Enclosure 1

Description and Assessment of the Proposed Changes

Subject: Application to Revise the Fuel Handling Accident Analysis, to Delete Technical Specification 3.9.4 "Containment Penetrations," and to Modify Technical Specification 3.3.6 "Containment Ventilation Isolation Instrumentation" for Sequoyah Nuclear Plant (SQN-TS-24-01)

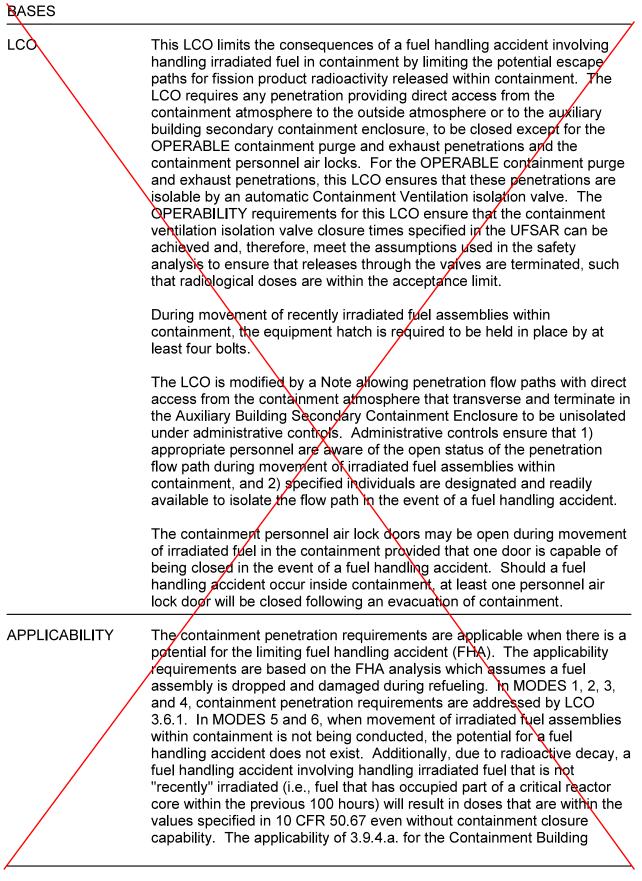
The other containment penetrations that provide direct access from containment atmosphere to outside atmosphere must be isolated on at least one side. Isolation may be achieved by an OPERABLE automatic isolation valve (either open or closed), or by a manual isolation valve, blind flange, or equivalent. Equivalent isolation methods must be approved and may include use of a material that can provide a temporary, atmospheric pressure, ventilation barrier for the other containment penetrations during irradiated fuel movements (Ref. 1).	
APPLICABLE SAFETY ANALYSES	During movement of irradiated fuel assemblies within containment, the most severe radiological consequences result from a fuel handling accident. The fuel handling accident is a postulated event that involves damage to irradiated fuel resulting from dropping a single irradiated fuel assembly (Ref. 2). The requirements of LCO 3.9.7, 'Refueling Cavity Water Level," in conjunction with a minimum decay time of 100 hours prior to irradiated fuel movement with containment closure capability, ensures that the release of fission product radioactivity, subsequent to a fuel handling accident, results in doses that are within the values specified in 10 CFR 50.67 or the NRC staff approved licensing basis (e.g., Regulatory Guide 1.183, (Ref. 3) limits).

Containment penetrations satisfy Criterion 3 of 10 CFR 50.36(c)(2)(ii)

APPLICABILITY (continued)

Equipment Hatch is "During the movement of recently irradiated fuel in containment" which maintains the containment closure requirements when the fuel has not sufficiently decayed to remain within these limits. The applicability of 3.9.4.b. and c. for the Containment Air Lock Doors and containment penetrations that provide direct access from containment atmosphere to outside atmosphere is "During movement of irradiated fuel in containment."

B 3.9.4 Containment Penetrations Deleted

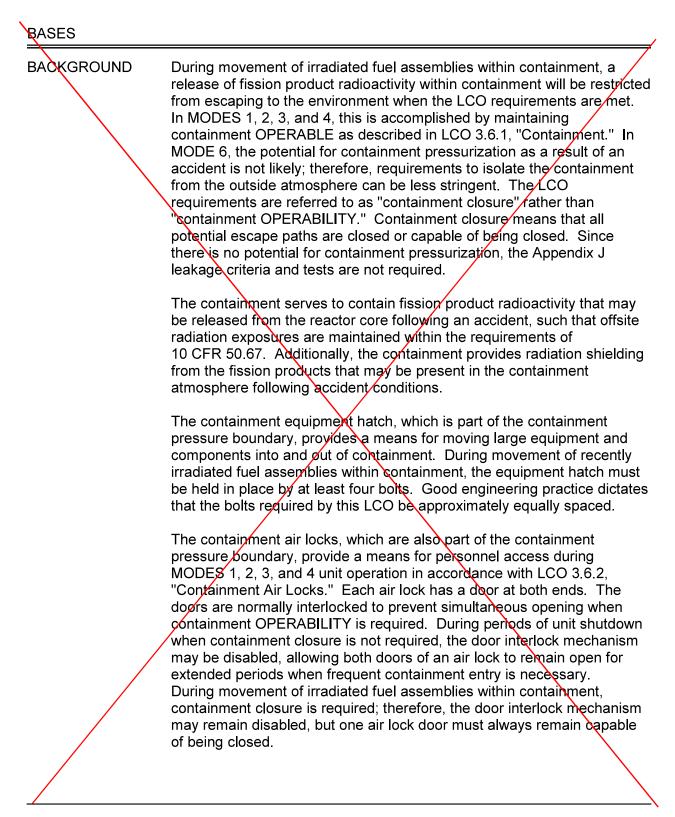
BACKGROUND (cor	ntinued)
	The requirements for containment penetration closure ensure that a release of fission product radioactivity within containment will be restricted to within regulatory limits.
	The Reactor Building Purge Ventilation (RBPV) System includes three subsystems. The normal subsystem includes four 24 inch purge penetrations and two 24 inch exhaust penetrations. The second subsystem, a pressure relief system, includes an 8 inch exhaust penetration. The third subsystem includes a 12 inch instrument room supply penetration and a 12 inch exhaust penetration. During MODES 1, 2, 3, and 4, no more than one pair of containment purge lines (one set of supply valves and one set of exhaust valves) may be opened (Ref. 4). None of the subsystems are subject to a Specification in MODE 5.
	In MODE 6, large air exchangers are necessary to conduct refueling operations. The normal 24 inch purge system is used for this purpose, and all valves are closed by Containment Ventilation Isolation in accordance with LCO 3.3.6, "Containment Ventilation Isolation Instrumentation."

The other containment penetrations that provide direct access from containment atmosphere to outside atmosphere must be isolated on at least one side. Isolation may be achieved by an OPERABLE automatic isolation valve (either open or closed), or by a manual isolation valve, blind flange, or equivalent. Equivalent isolation methods must be approved and may include use of a material that can provide a temporary atmospheric pressure, ventilation barrier for the other containment penetrations during irradiated fuel movements (Ref. 1).
APPLICABLE SAFETY ANALYSES	During movement of irradiated fuel assemblies within containment, the most severe radiological consequences result from a fuel handling accident. The fuel handling accident is a postulated event that involves damage to irradiated fuel resulting from dropping a single irradiated fuel assembly (Ref. 2). The requirements of LCO 3.9.7, "Refueling Cavity Water Level," in conjunction with a minimum decay time of 100 hours prior to irradiated fuel movement with containment closure capability, ensures that the release of fission product radioactivity, subsequent to a fuel handling accident, results in doses that are within the values specified in 10 CFR 50.67 or the NRC staff approved licensing basis (e.g., Regulatory Guide 1.183, (Ref. 3) limits).

Containment penetrations satisfy Criterion 3 of 10 CFR 50.36(c)(2)(ii).

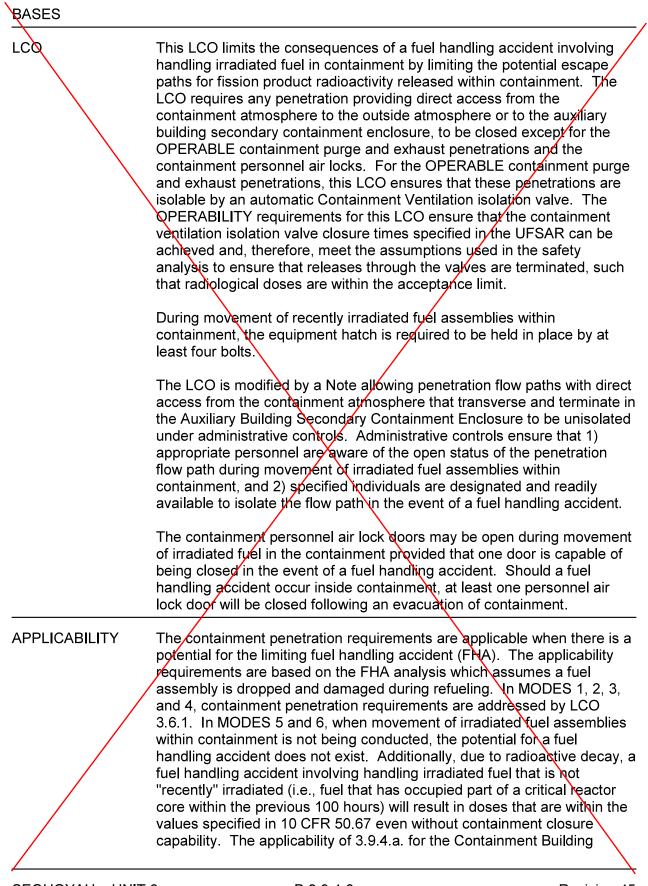
APPLICABILITY (continued)

Equipment Hatch is "During the movement of recently irradiated fuel in containment" which maintains the containment closure requirements when the fuel has not sufficiently decayed to remain within these limits. The applicability of 3.9.4.b. and c. for the Containment Air Lock Doors and containment penetrations that provide direct access from containment atmosphere to outside atmosphere is "During movement of irradiated fuel in containment."
